SUBJECT: Calvert Cliffs Nuclear Power Plant
Unit No. 1; Docket No. 50-317
Request for Additional Information Re: Long-Term Carborundum Coupon
Surveillance Program

**RESPONSE TO REQUEST FOR ADDITIONAL INFORMATION –
LONG-TERM CARBORUNDUM COUPON SURVEILLANCE PROGRAM**

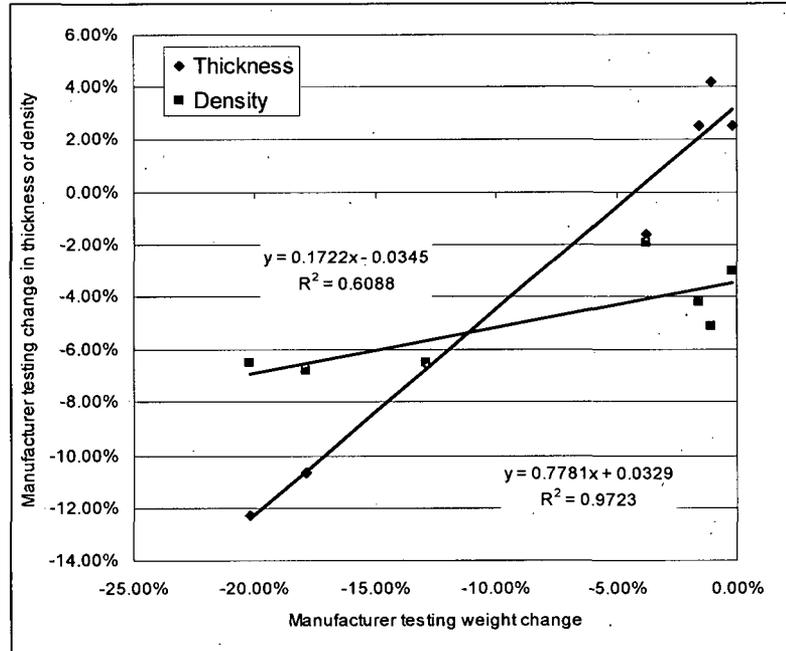
1. *On page 2 of Attachment 1, it is stated that the proposed long-term coupon surveillance program will consist of visual, weight, and dimensional determinations. Please provide justification for the elimination of sample thickness from your dimensional determinations.*

Measurement of surveillance coupon thickness is not part of the currently approved surveillance program for carborundum. As such, there are no known baseline measurements of thickness for the current long-term surveillance assembly (LTSA) coupons. The carborundum material is composed of boron carbide particles in a matrix of phenol formaldehyde resin with fiberglass reinforcement. The original manufacturer test program, detailed in Reference (1), found that there were no statistically significant changes in length or width of the test samples with irradiation to 10^{11} rad in deionized water and 10^{10} rad in borated water (Reference 1, Tables XIII & XIV). Similarly, the length and width for the CCNPP surveillance coupons have not changed significantly during irradiation. For the last accelerated surveillance assembly (ASA) coupons examined, the largest change in length was 0.485%, while the largest change in width was 1.95%. Note that these small changes are believed to result from curvature of the thin coupon during the drying process.

Since coupon length and width do not change significantly with irradiation, the change in coupon weight will be directly proportional to changes in thickness and/or density. Review of the original manufacturer's irradiation test program data (Reference 1, Tables XIII & XIV) suggest that changes in weight with irradiation are more highly correlated with changes in thickness than in density as shown below.

Projected Life of Carborundum Racks

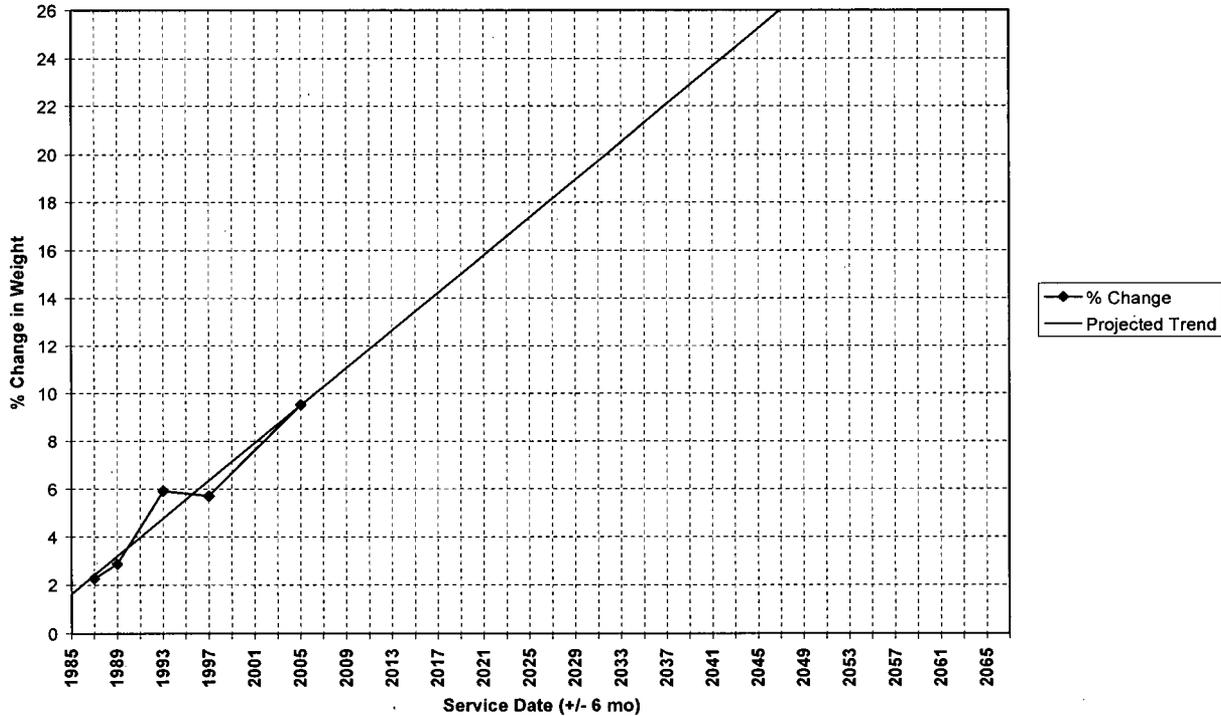
4. Please provide the results of the coupon surveillance performed in 2005. Did the results correspond to the extrapolation performed in response to NUREG-1705, Section 3.10.2.4? With this new data point, does the expected boron loss change for the 70-year life span of the Unit 1 SFP (26.2 percent)?

The average weight loss for the 2005 ASA coupon was 9.5 wt%. The graph below shows the projected time (2047) to reach the 26% weight loss assumed in the criticality analysis of record. This projected time is more than the 10 years beyond the period of extended operation for either Unit 1.

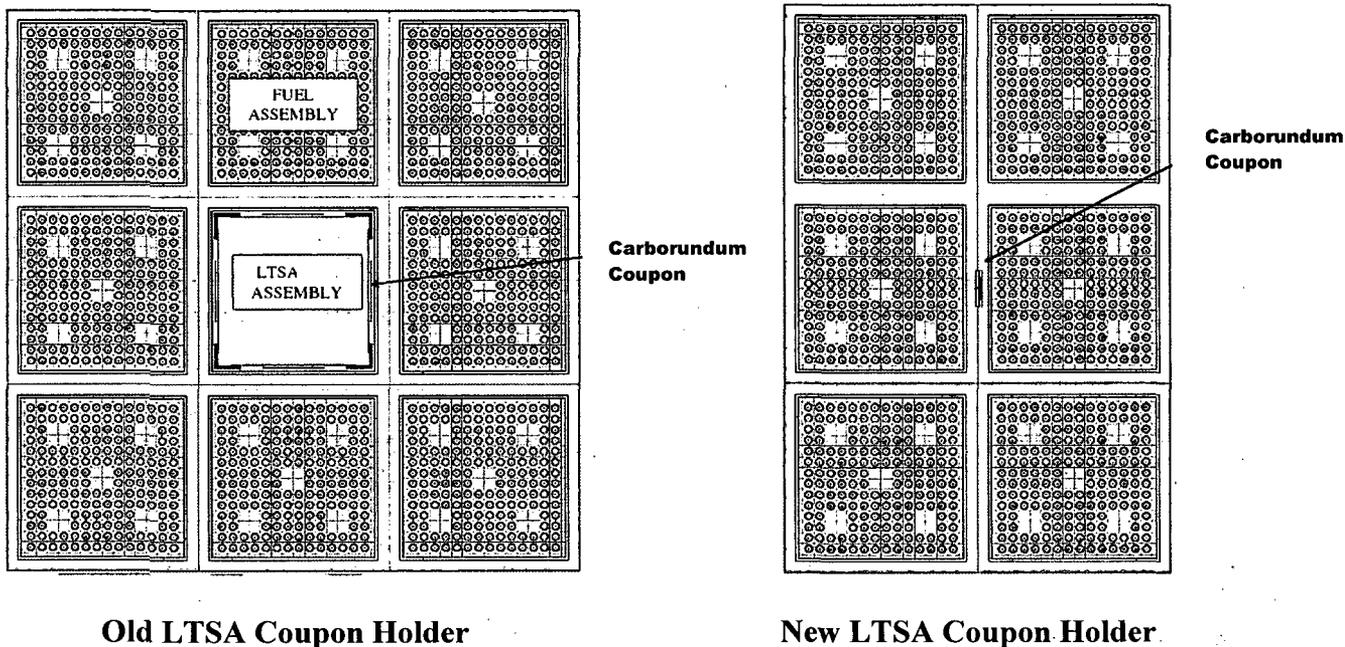
5. On page 3 of Attachment 1, it is indicated that the new coupon tree for the proposed long-term surveillance program is expected to be installed in 2007. Please discuss the status of the new coupon tree being installed.

Long-term surveillance assembly coupons 32, 33, 34, 39, 40, 41, 42, 47, and 49 were removed from the pool and the old LTSA coupon holder on September 7, 2007. They were installed on the new coupon trees and reinserted into the pool on September 10, 2007. The figure below provides a visual representation of the old and new coupon holder configurations.
